**Re: Lonza Biologics – Proposed Industrial Development
Traffic Peer Review Response 2
Supplemental PB Submission – Amended Site Plan Review Application**

PROPOSED INDUSTRIAL DEVELOPMENT

70 & 80 CORPORATE DRIVE PORTSMOUTH, NEW HAMPSHIRE

LAST REVISED: NOVEMBER 9, 2023

Last Save Date: November 8, 2023 6:59 PM By: HANSEN
 Plot Date: Thursday, November 09, 2023 Plotted By: Neil A. Hansen
 File Location: J:\L-0700-Lonza Biologics Expansion.was 12/26/2026 Project AbstracteDrawingsAutoCADv...-0700-026-C-DTLS.dwg Layout: Tab: C-502

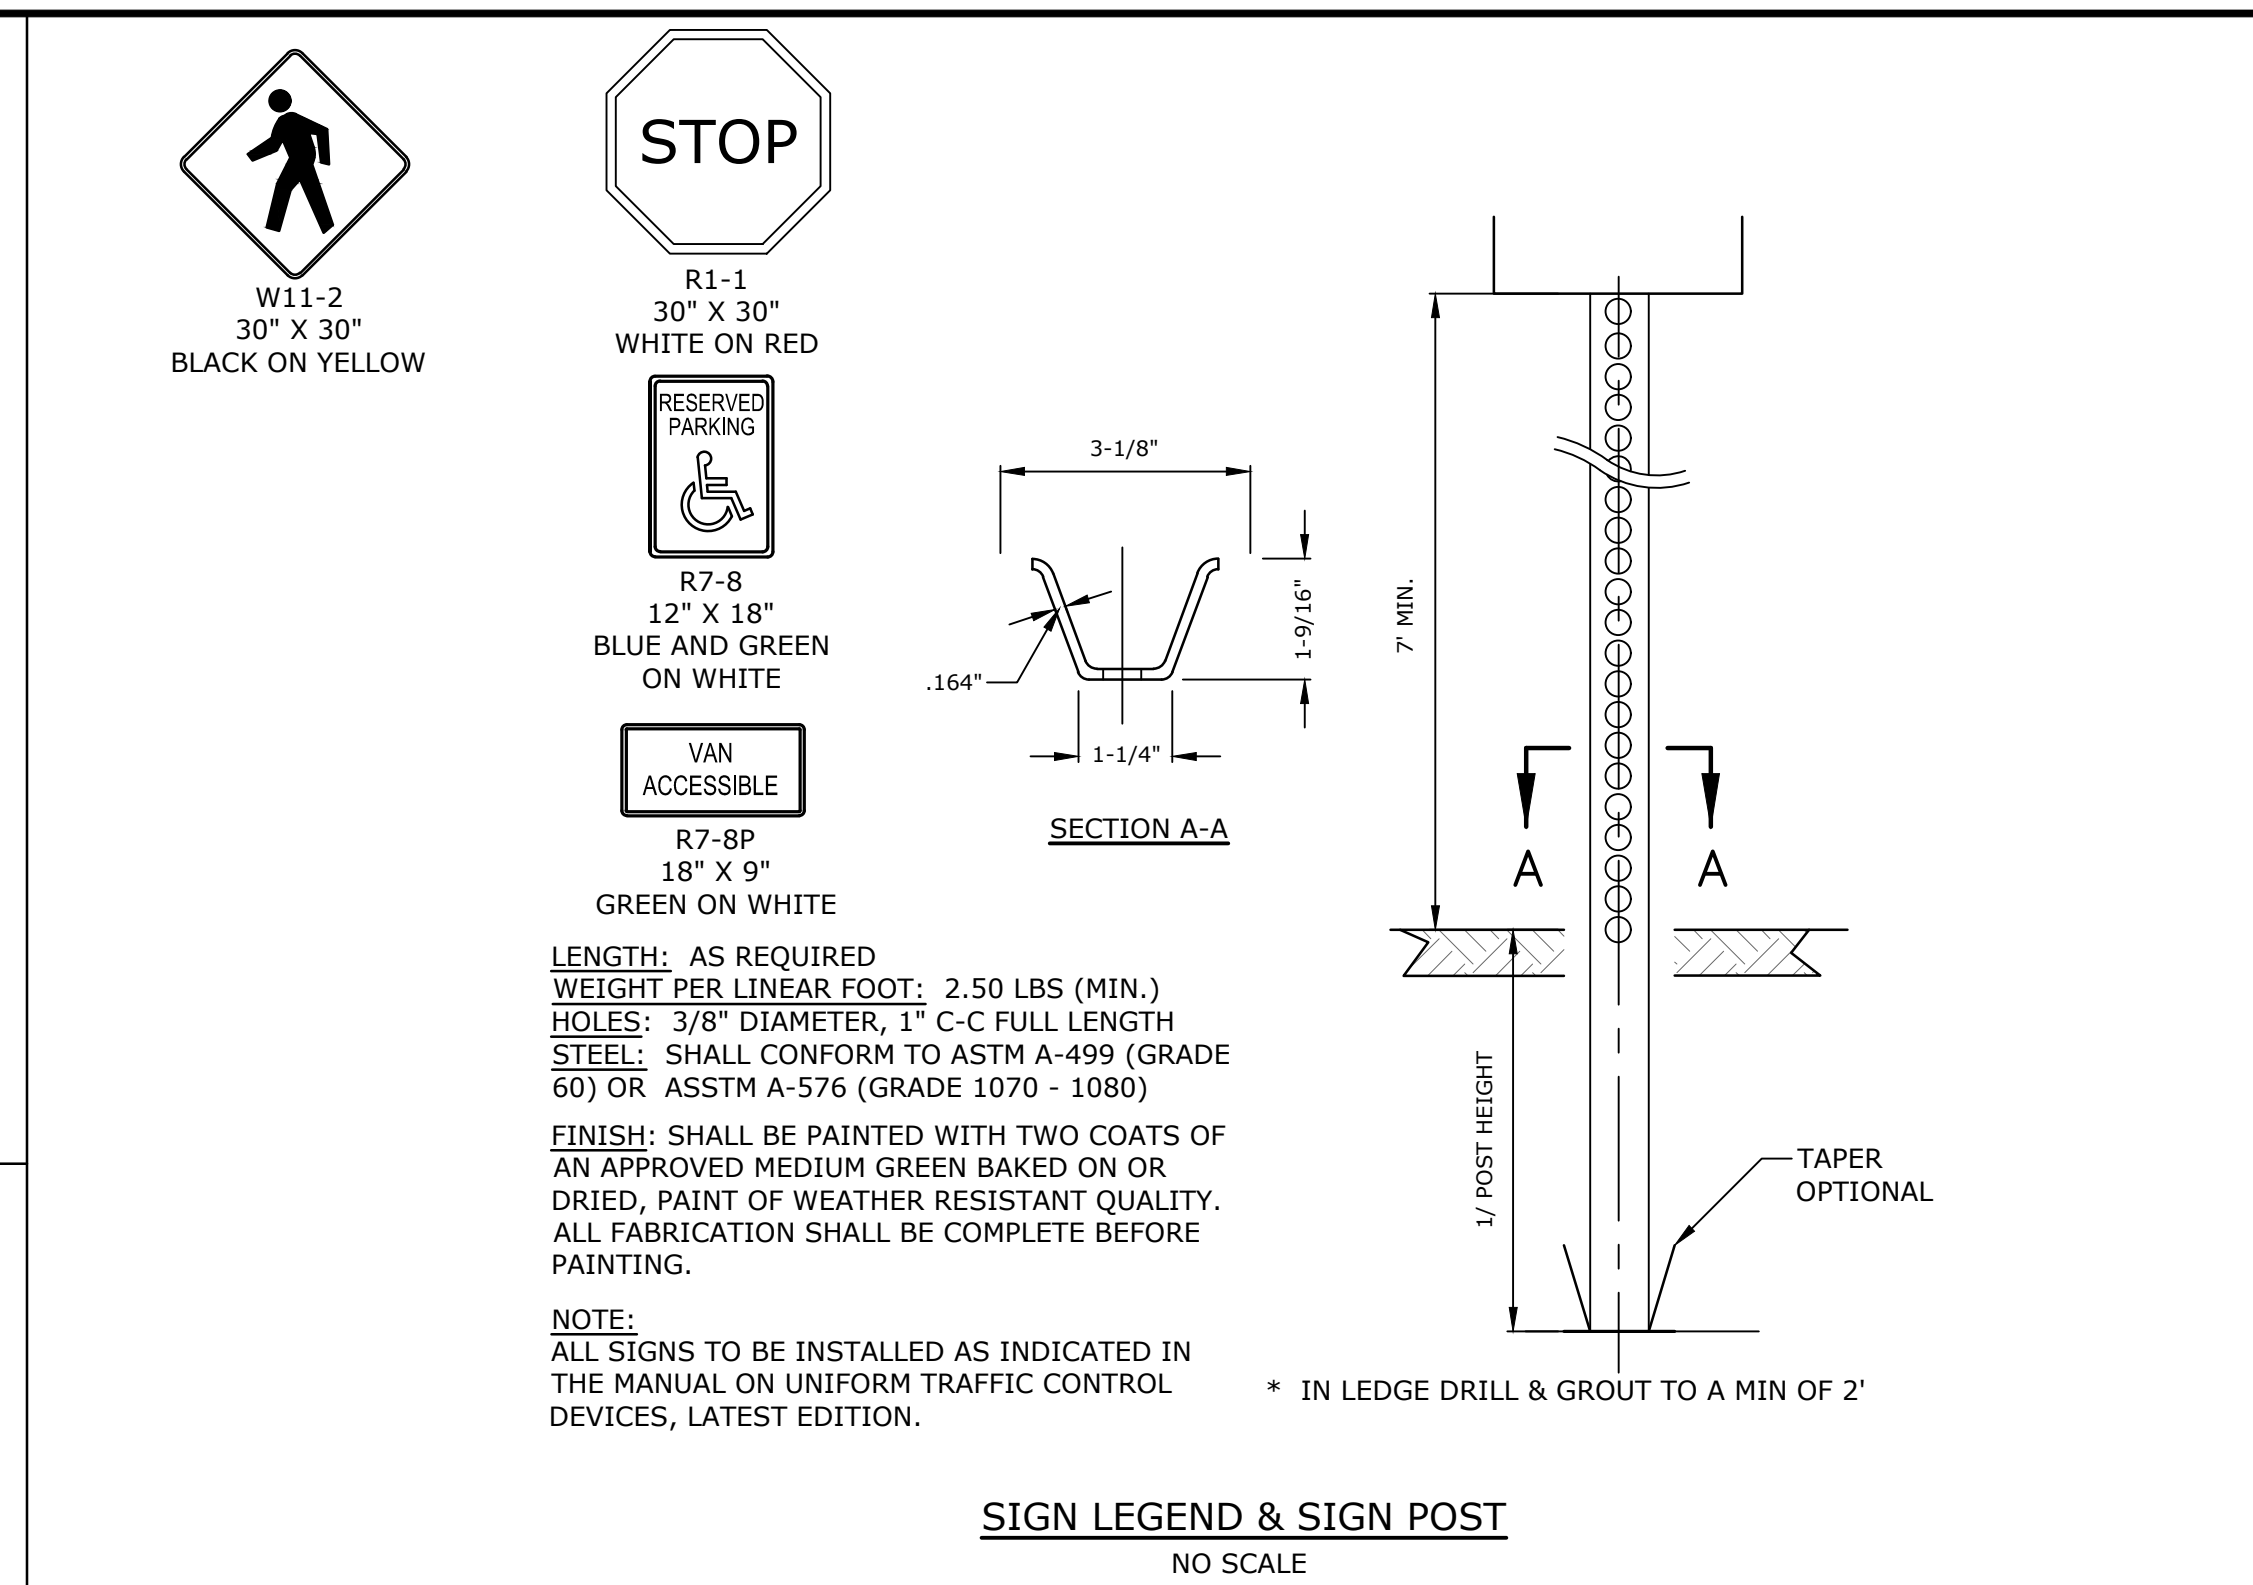
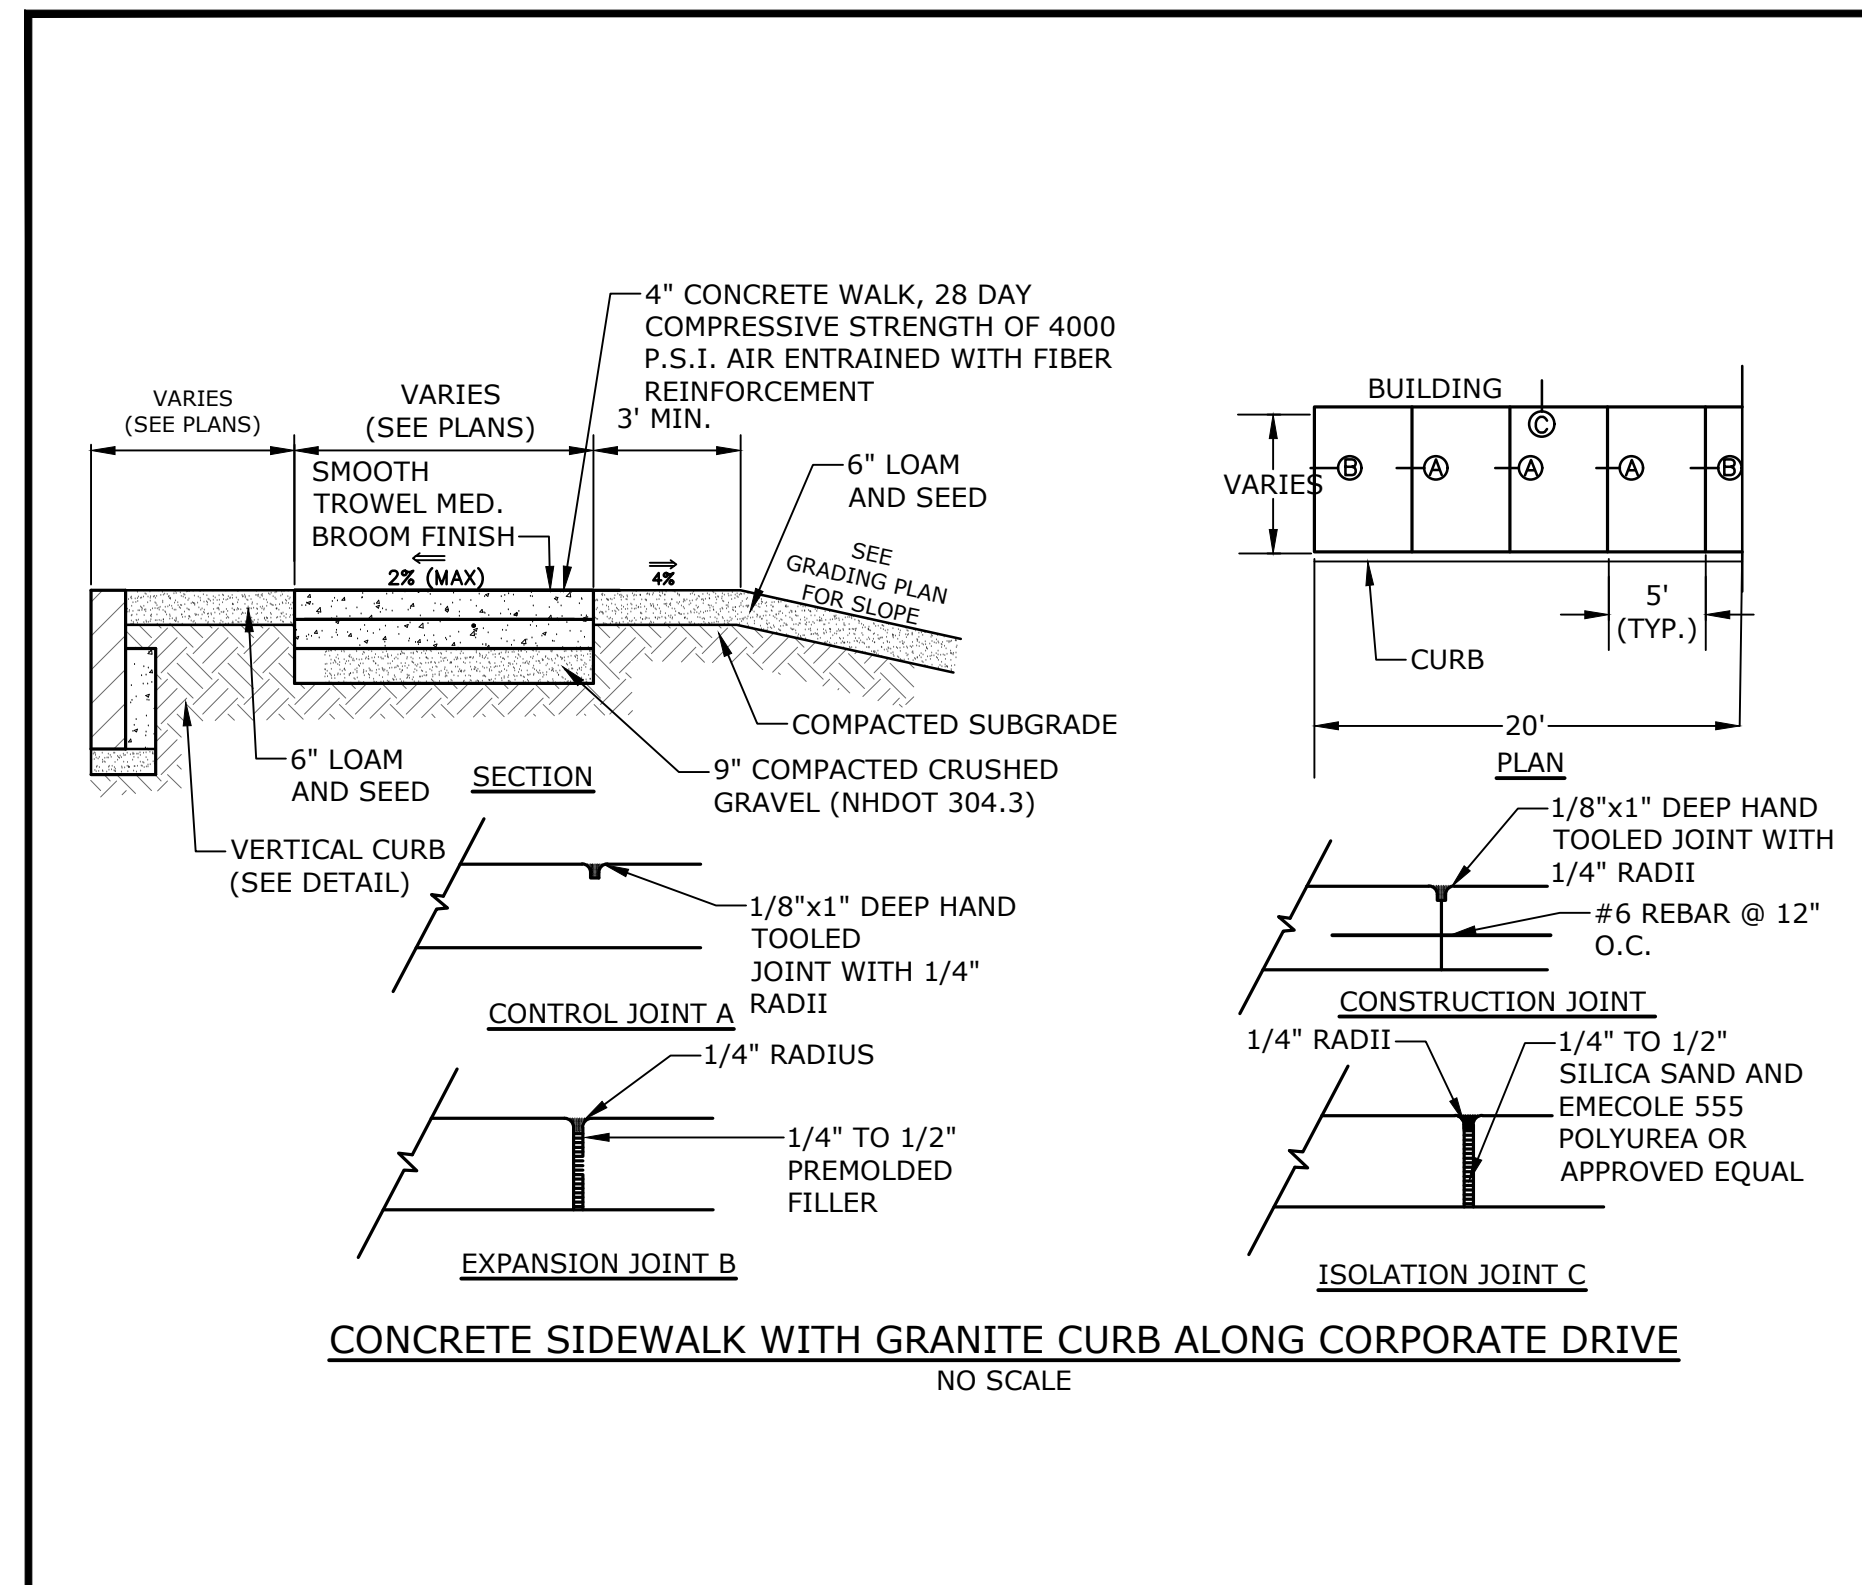
- A central sidewalk has been added through the 150 space parking area connecting to the currently proposed sidewalk. (Sheet C-165)
- A second trash compactor has been added to the site adjacent to the Utility Building. Truck turning was studied to confirm access. (Sheet C-166)
- Pedestrian warning signs have been added to the plans as recommended. (Sheets C-165, C-167 & C-502)
- Crosswalk Striping detail has been revised to note an 8' width. (Sheet C-502)
